TfNSW reference: STH14/00018/02

Your reference: SSD-48225958

**REQUEST FOR SECRETARY'S ENVIRONMENTAL ASSESSMENT REQUIREMENTS (SEARS) –  
GUNDARY SOLAR FARM – WINDELLAMA ROAD GUNDARY**

**SSD-48225958 – Gundry Solar Farm – Windellama Road GUNDARY**

FIGURE 3.3  
Transport Route Options

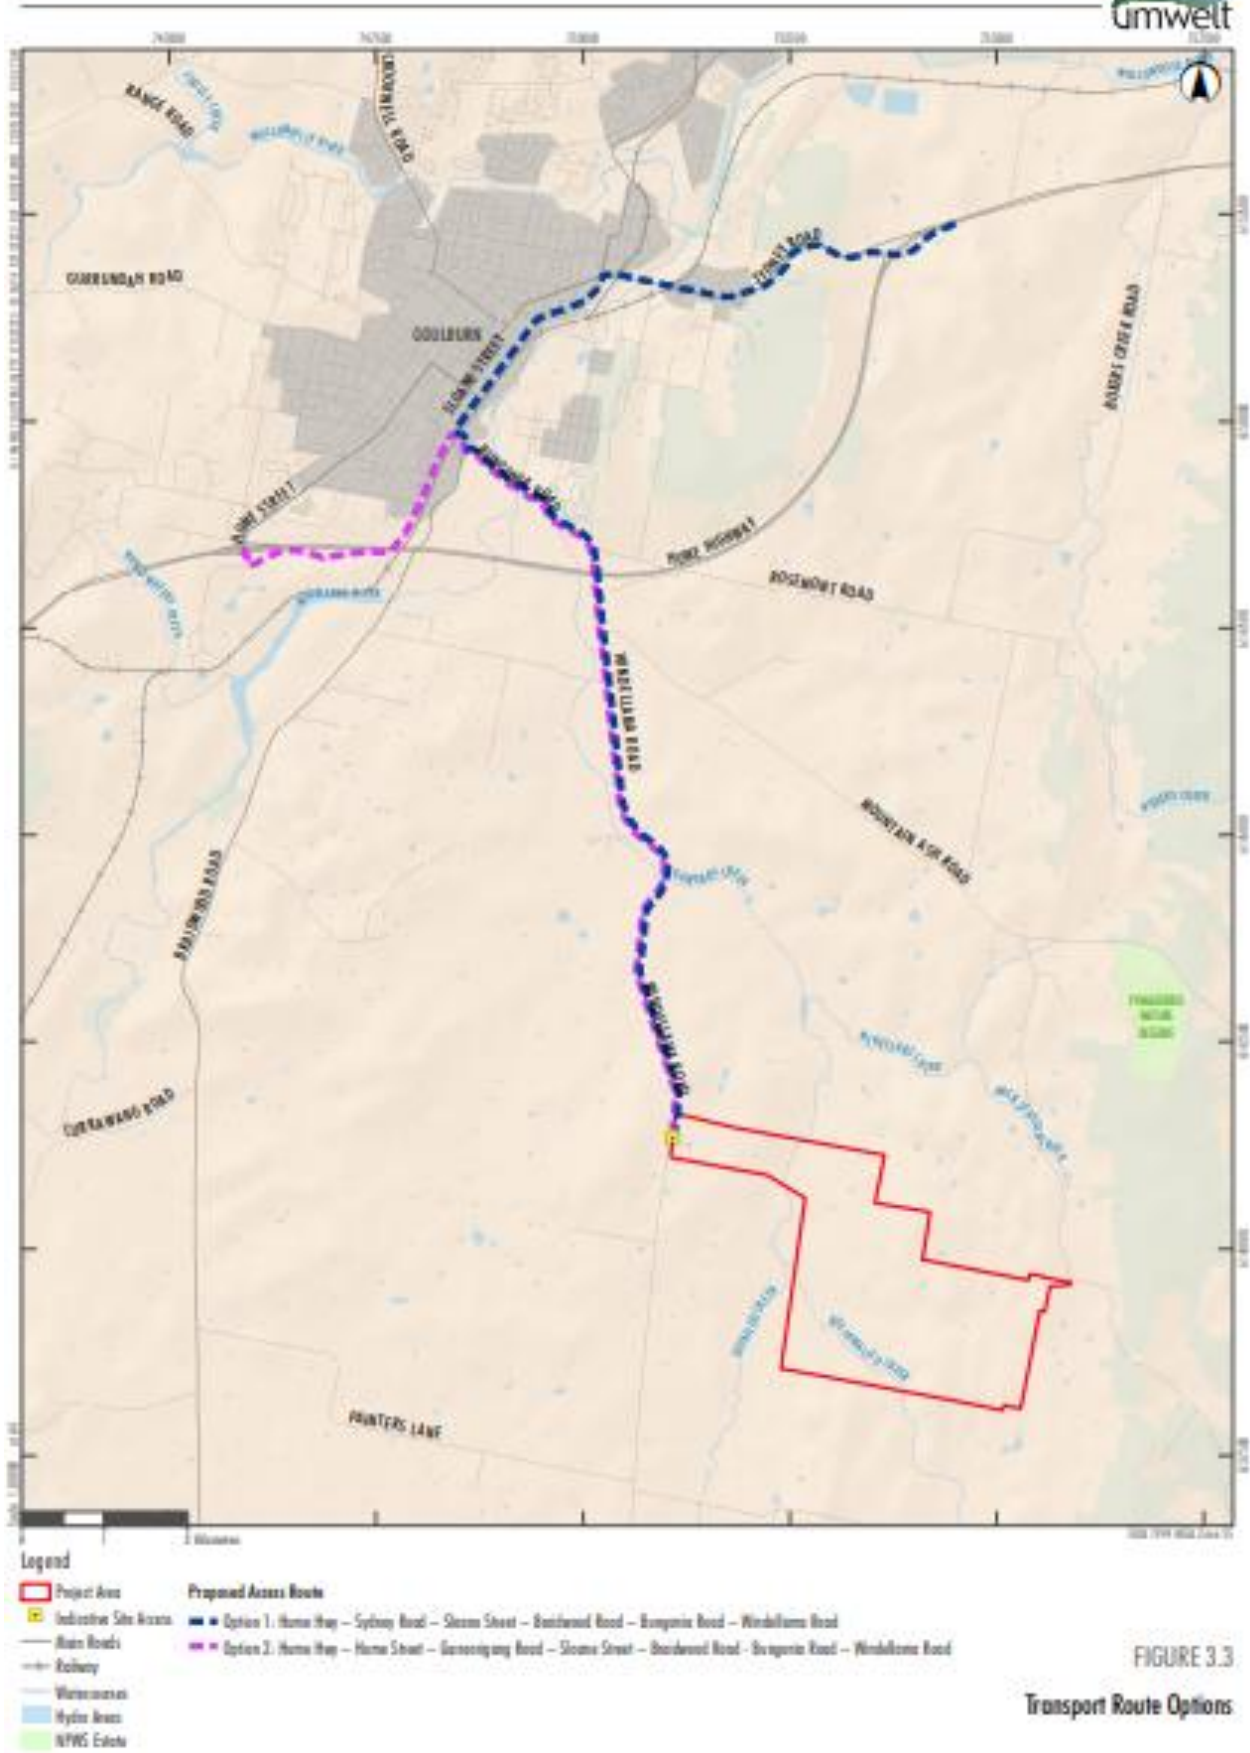
- xii. If B-Double and Oversized or Over Mass (OSOM) vehicle movements are associated with the proposal TfNSW requests the following:
  - i. Route maps (from origin to destination), if they differ from the routes outlined in attachment 3

- ii. An assessment of the routes and required road network changes to facilitate the B-Double and Oversized or Over Mass (OSOM) vehicles.

- iii. The number of OSOM movements, the intended time for OSOM movements to occur and location of rest areas required along OSOM routes must also be provided
